CAMDEN COUNTY PLANNING BOARD
CHARLES J. DEPALMA COMPLEX
2311 EGG HARBOR ROAD
LINDENWOLD, NJ 08021

April 28th, 2020

**CAMDEN COUNTY PLANNING BOARD
COUNTY ENGINEER'S REVIEW
OF SUBDIVISIONS AND
SITE DEVELOPMENT PLANS**

**COUNTY PLAN:
SP-3-1-19**

WB-40 TRUCK PULL IN AT LOADING AREA

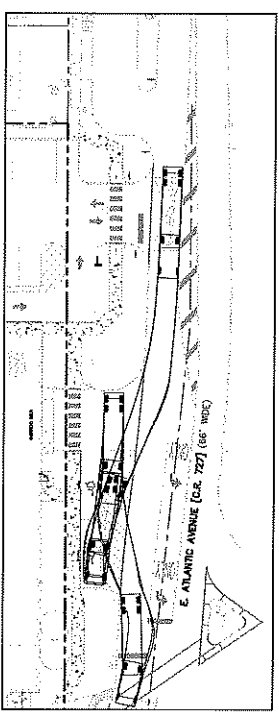
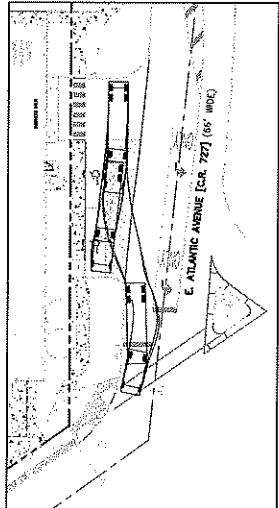
3. Two handicapped spaces are proposed on E. Atlantic Avenue within the County ROW. These two spaces also serve as the loading zone for truck deliveries and pick-up. The applicant should be prepared to testify and provide additional information about the use of this area for deliveries and describe the delivery schedule, type of truck and frequency of deliveries.

- 3.3.1.10.E Driveway and Apron Material ***(Plan Does Not Conform)*** The County recommends that the applicants engineer relook at the driveway configuration along E. Atlantic Ave. Cr. 727 and how it interacts with the local Atlantic Ave. connecting to the driveway and why the current configuration does not work for their purposes.
